* INTERIOR COLOUR SCHEME *

CONSTRUCTION SUMMARY

Forestside Estates Inc.

LOT NUMBER	PHASE	HOUSE TYPE	CLOSING DATE
49	8	WHITE ORCHID (45-05S4A)-ELEV A-STD MAIN-4 BED	27-Jun-24

* Main Floor - 10'-0" Ceiling *

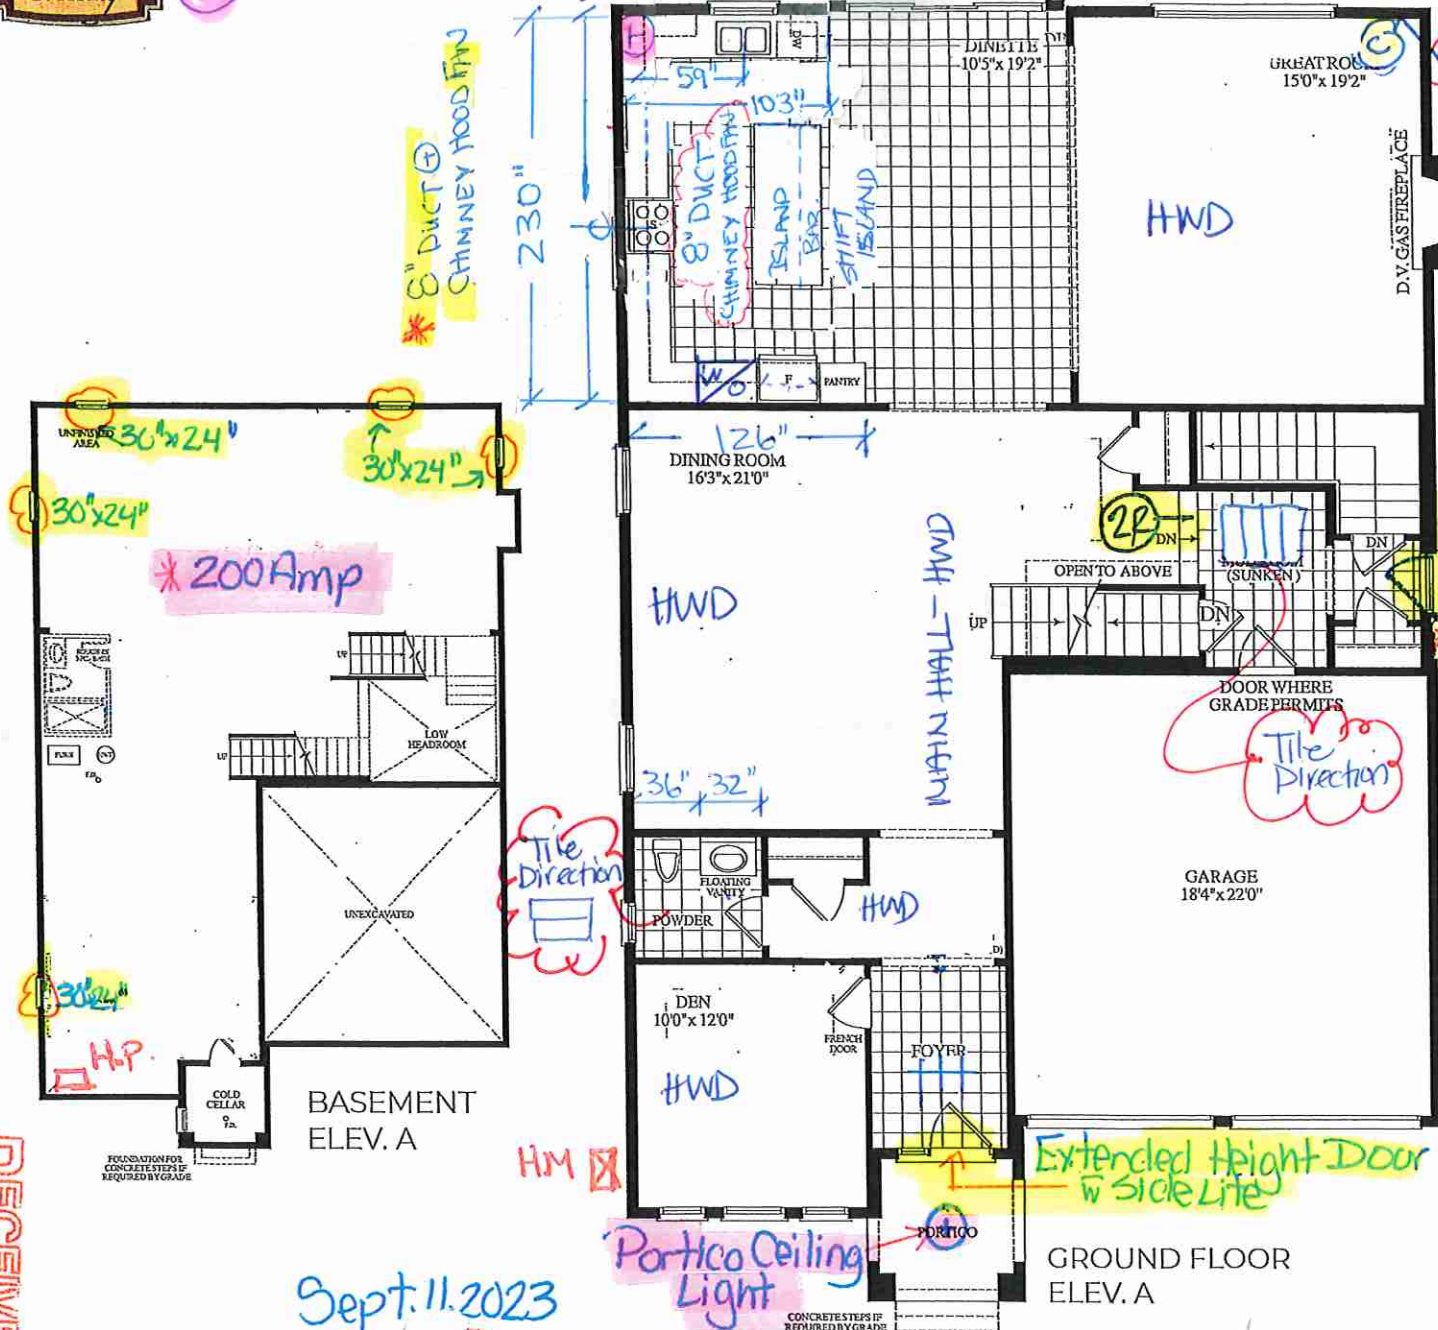
1 - BACK EXTERIOR PATIO SLIDERS- Delete standard window on either side of patio slider and shift the Patio slider down toward Graet Room (See Sketch)

1 - KITCHEN- Relocate the builders standard 48"x52" window from side exterior elevation to rear wall elevation. To be isntalled above new sink location (See Sketch)

5 - BASEMENT - Increase FIVE (x5) Basement Windows from Standard 30 IN (W) x 16 IN (H) TO LARGER 30 IN (W) x 24 IN (H) (with Possible Window Wells) (See Sketch) Note:
1 - BASEMENT - Install Upgrade 200 AMP Service in lieu of builders standard 100 Amp (See Sketch) Note:
1 - MAIN FLOOR - Install EXTENDED HEIGHT 10'-0" CEILINGS (Includes Extended Height Archways & 8 Foot Standard Doors) (See Sketch) Note:
1 - FRONT EXTERIOR - FRONT DOOR - Install EXTENDED HEIGHT Single Front Door with Applicable Side Lite (Delete Transom Window Above) in lieu of builders standard height single door with side lite (See Sketch) Note:
1 - SIDE EXTERIOR - Install OPTIONAL SIDE DOOR ENTRANCE (Includes Applicable Exterior Coach Light) **If Grade Permits** (See Sketch) Note:
1 - FRONT EXTERIOR - In addition to builders standard exterior coach light, Install ONE (x1) EXTERIOR PORTICO CEILING LIGHT **Includes Basic Fixture** To be controlled by a seperate switch (See Sketch) Note:

KITCHEN

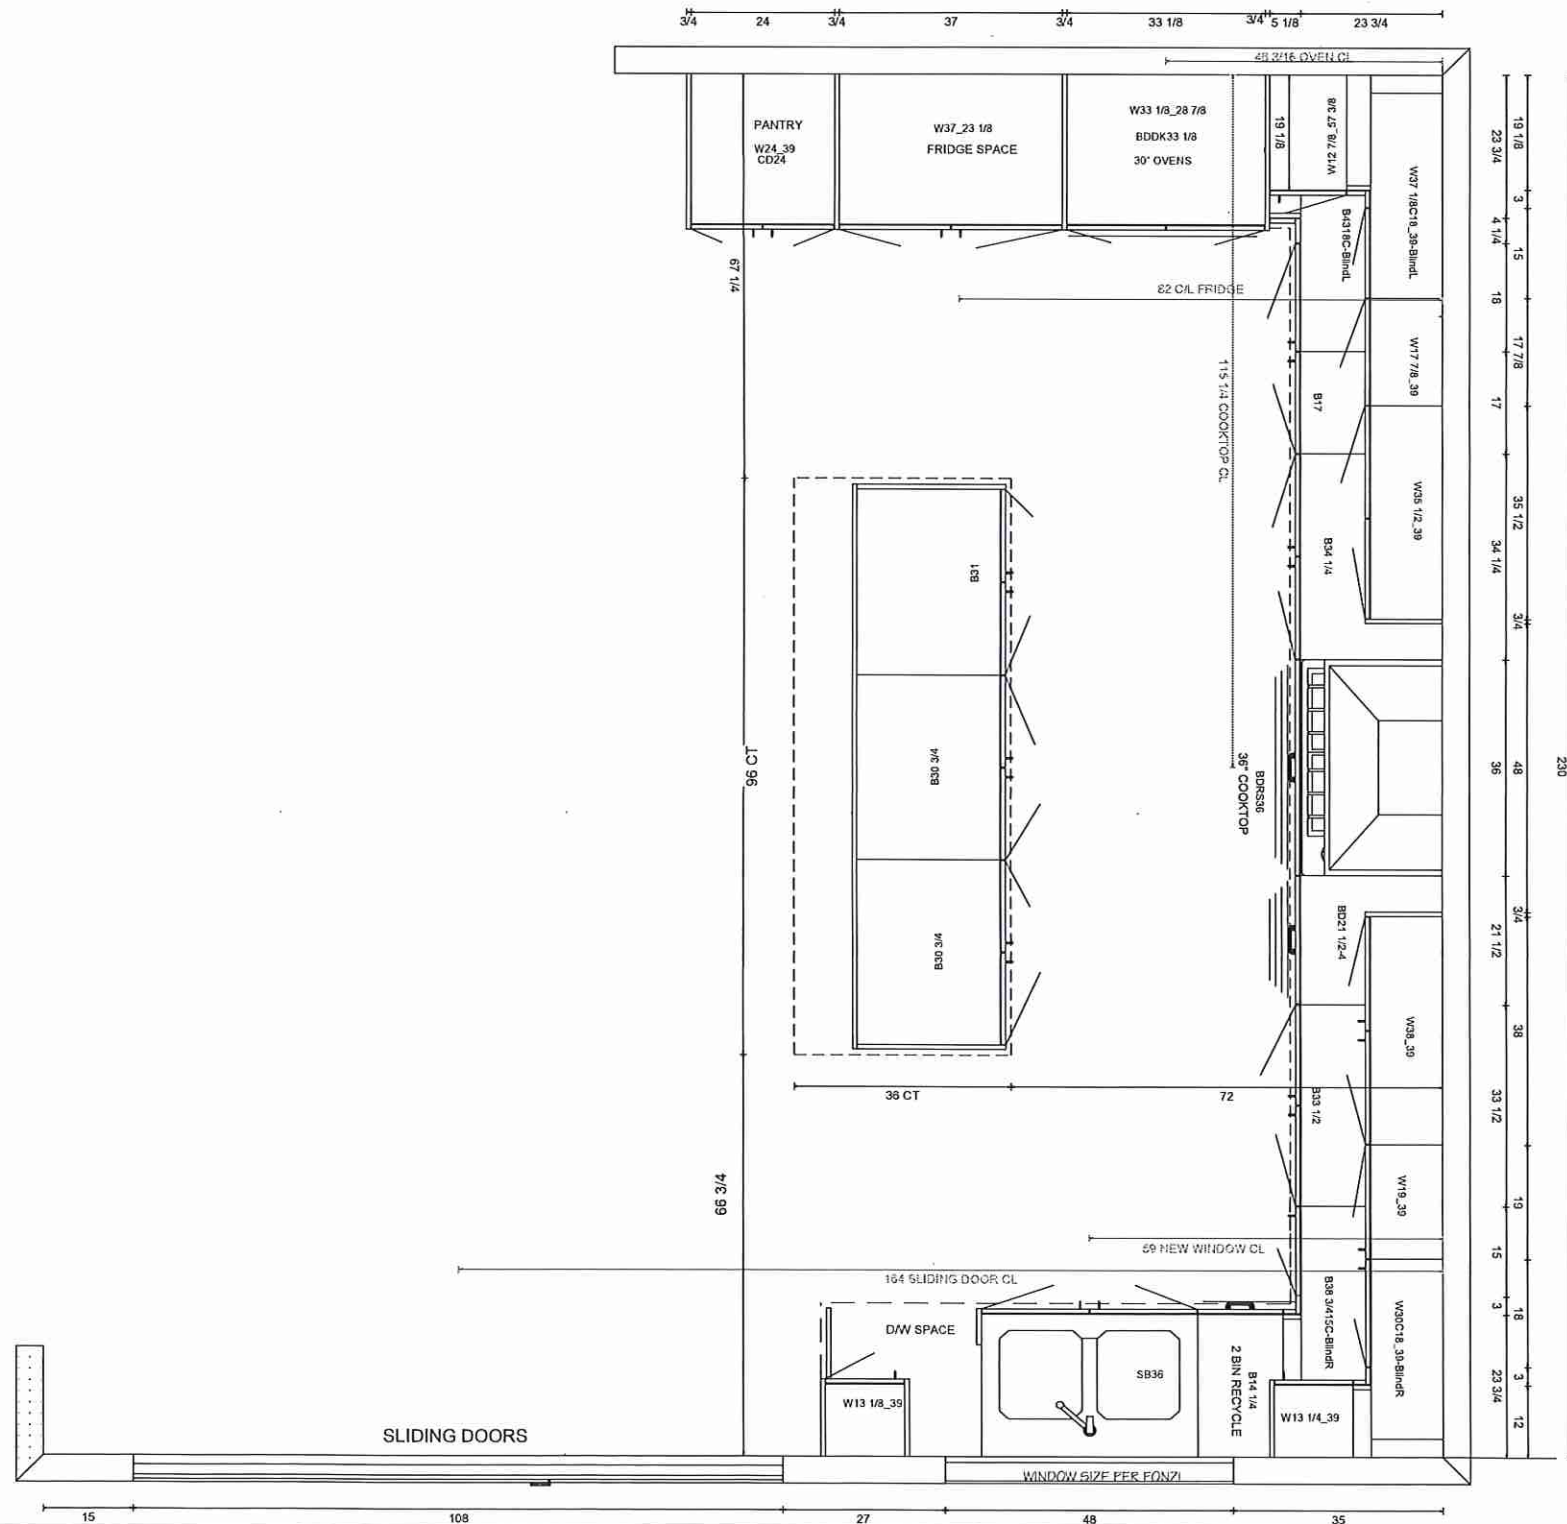
1 - KITCHEN- Relocate the sink and dishwasher to the rear of house under new 48"x52" window

1 - KITCHEN- Install additional standard Base Cabinetry and additional Upper cabinetry with additional standard Crown Moulding to accommodate the reconfiguration of the kitchen (See Sketch)

1 - KITCHEN- Pull the cabient forward and bring the cabinet to the counter and panel botton corner (See Sketch)

1 - KICTHEN- Install a Double Bin Pull out Grabge (See Sketch)

1 - KITCHEN-Accommodate the cabinetry for a built in Oven/Micro in the kitchen (See Sketch)

KITCHEN FRIDGE WALL

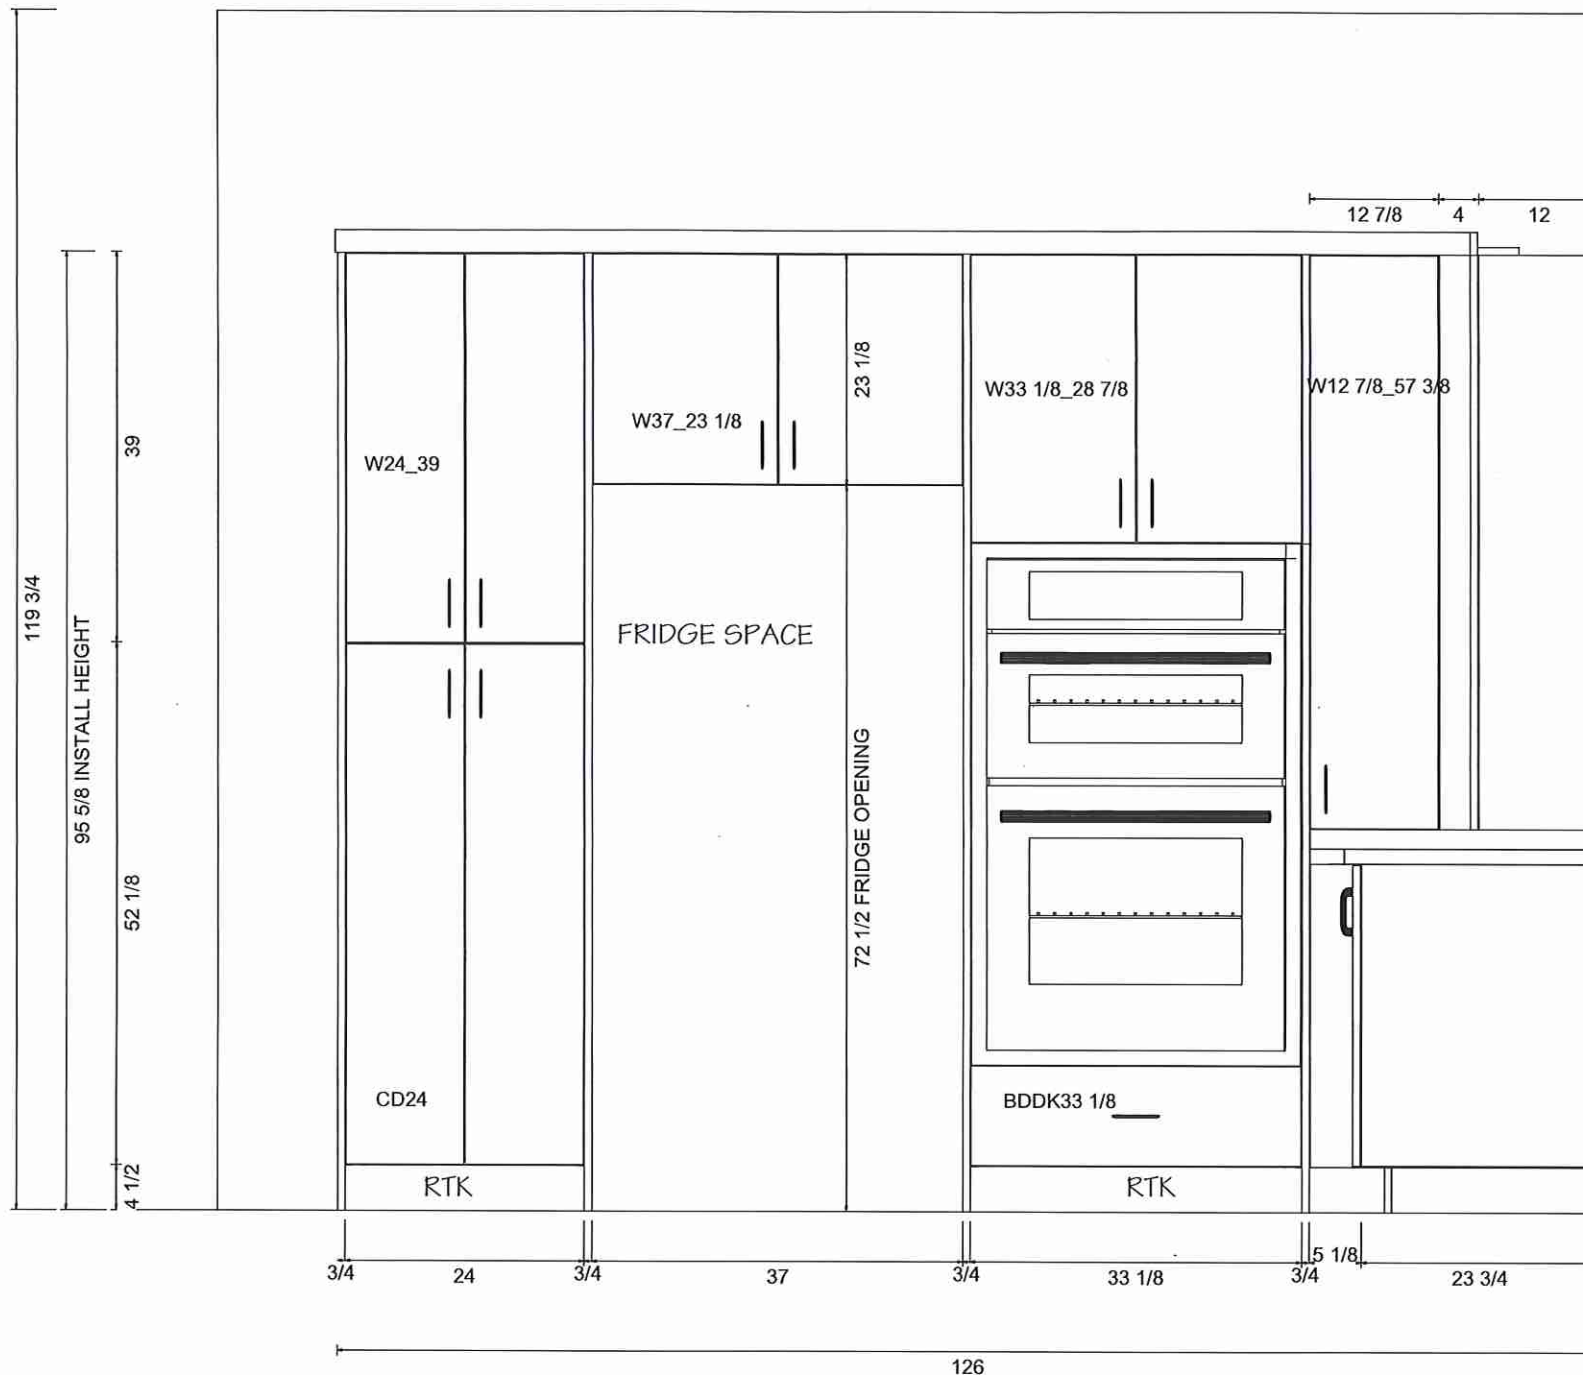
1 - KITCHEN- Install Deep Upper cabinets above the fridge (See Sketch)

KITCHEN COOKTOP WALL
DOOR STYLE: EURO
DOOR PROFILE: N/A
DOOR MATERIAL: MELAMINE
DOOR FINISH: FASHIONISTA
INTERIORS: WHITE
CROWN MOLD: STD EURO
PAND MOLD: N/A
LIGHT VALANCE: N/A
INT HW: STANDARD
INSTALL HEIGHT: 95 5/8"H
CEILING HEIGHT: 119 3/4"H
HW:
COUNTERTOP

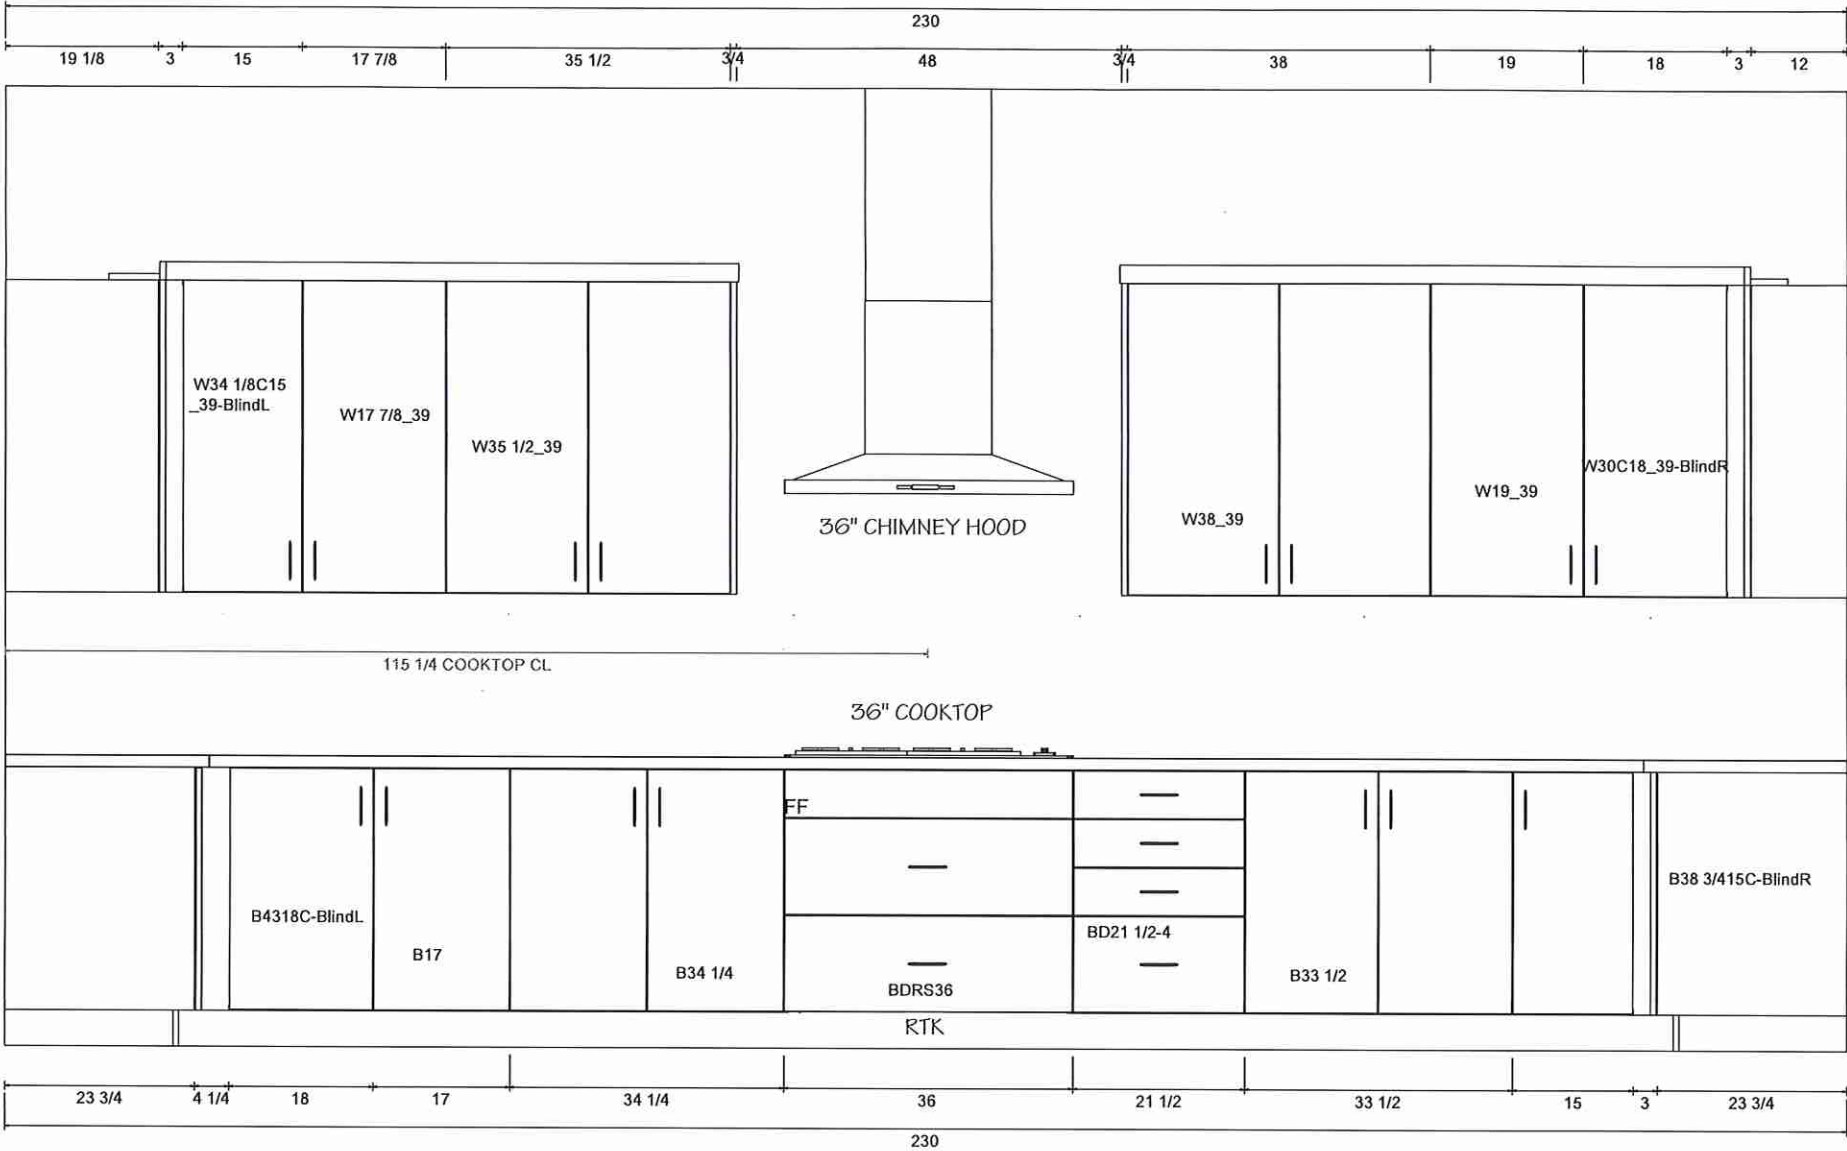
1 - KITCHEN- Shift the stove and the exhaust fan in the kitchen to be centred (See Sketch)

1 - KITCHEN- Accommodate the cabinetry for a 36" Cook Top with pot and Pan Drawers below (See Sketch)

1 - KITCHEN- Accommodate the counter top Cut out for a 36" Cook Top in the kitchen See Sketch)
